# UNITED STATES PATENT AND TRADEMARK OFFICE

APPLICATION NO.	FILING DATE	FIRST NAMED INVENTOR	ATTORNEY DOCKET NO.	CONFIRMATION NO.
10/660,611	09/12/2003	Chun Ho Fan	50626.55	6110

# Office Action Summary

## **DETAILED ACTION**

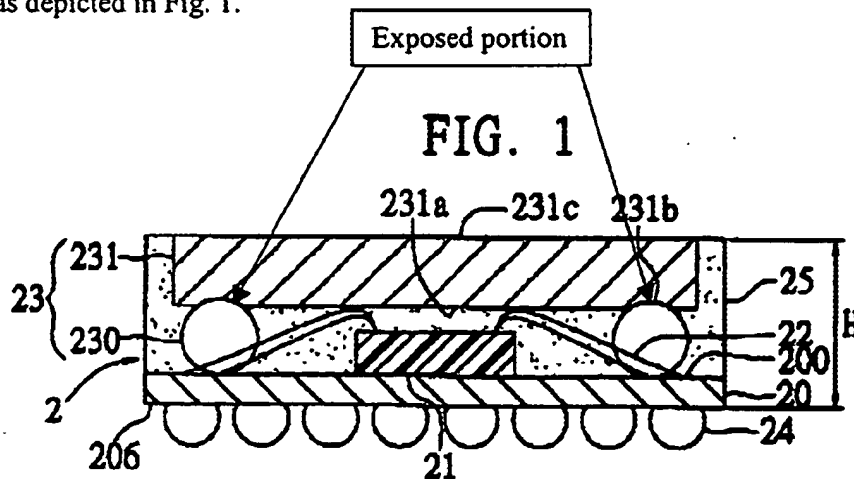
Applicants argue that "Huang et al. certainly fails to teach or suggest the feature of *an overmold material encapsulating said semiconductor die and said balls on said substrate such that portions of said balls that are disposed farthest from said substrate are exposed at an exterior of said Integrated circuit package...*"

In response to applicants' contention, it is respectfully submitted that Huang et al. '0113308 disclose all the claimed limitations including "overmold material encapsulating said semiconductor die and said balls on said substrate such that portions of said balls that are disposed farthest from said substrate are exposed at an exterior of said Integrated circuit package," as depicted in Fig. 1.

As shown above, the exposed portion of the balls 230 is at exterior portion of the package which is farthest from the substrate 20. In addition the heat sink 231 is in contact with the exposed portion of balls 230 and the overmold material 25 also encapsulating the semiconductor die 21 and the balls 230. Furthermore, the semiconductor die 21 is electrically connected to solder balls 24 for external connection via through conductive traces 22 (see Page 2, Paragraph 0024).

Therefore, the rejection of claims 13, 15- 17, 20-22, 24 and 25 under 35 U.S.C. § 102(b) is deemed proper. In addition, the rejection of claim 23 under 35 U.S.C. § 103(a) is deemed proper and the *prima facie* case of obviousness has been met.
